# Access Compliance Report

## Public Rights-of-Way

Intersection ID: 13708	Main Street: WEST_BV	Cross Street: WICKFORD_PL	Location: NE
ADA ID: 02E6E5BCCD93	Ramp Type: Perp	Initial Pass/Fail: Fail	Overall Compliance: No
Severity Score: 12.5			
Codes/Mitigation Info/Possible Solution		Field Measurements/Component Compliance

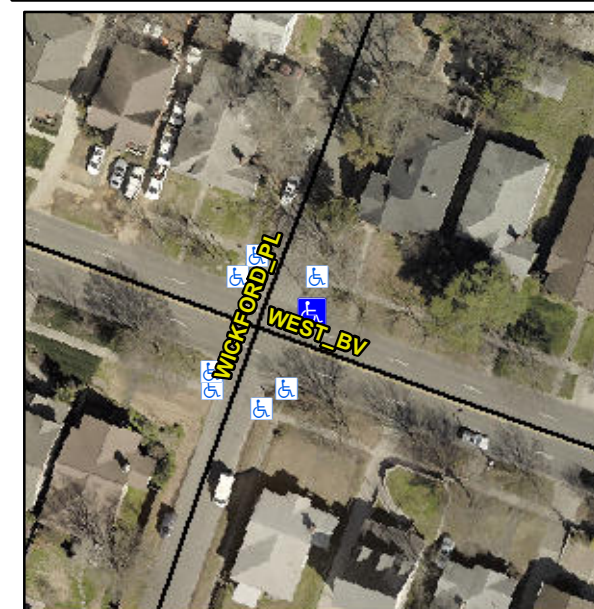
**Not Found, R304.2.2**

Compliance	Description	Data	Compliance	Description	Data
N/A	Ramp Length (in)	50.0	No	Ramp Slope (%)	8.8
Yes	Ramp Width (in)	48.0	Yes	Ramp XSlope (%)	1.1
N/A	Flare Type LT	N/A	N/A	Flare Type RT	N/A
N/A	Flare Slope LT (%)	N/A	N/A	Flare Slope RT (%)	N/A
N/A	Flare Traversable LT?	N/A	N/A	Flare Traversable RT?	N/A
N/A	Landing Length (in)	N/A	N/A	DWS Provided?	N/A
N/A	Landing Width (in)	N/A	N/A	DWS Contrast?	N/A
N/A	Landing Slope (%)	N/A	N/A	DWS Length (in)	N/A
N/A	Landing X Slope (%)	N/A	N/A	DWS Full Width?	N/A
N/A	Landing Curb? (Y/N)	N/A	N/A	DWS Offset (in)	N/A
N/A	Shared Landing?	N/A			
N/A	Gutter Ponding?	N/A	N/A	Gutter Slope (%)	N/A
N/A	Gutter Lip Ht (in)	N/A	N/A	Gutter X Slope (%)	N/A
N/A	Painted X Walk1?	No	N/A	Painted X Walk2?	N/A
	X Walk 1 Direction	To SW		X Walk 2 Direction	N/A
N/A	X Walk 1 Width (in)	N/A	N/A	X Walk 2 Width (in)	N/A
	X Walk 1 Slope (%)	4.8		X Walk 2 Slope (%)	N/A
	X Walk 1 X Slope (%)	0.7		X Walk 2 X Slope (%)	N/A

**Remove & Replace Entire Ramp.**
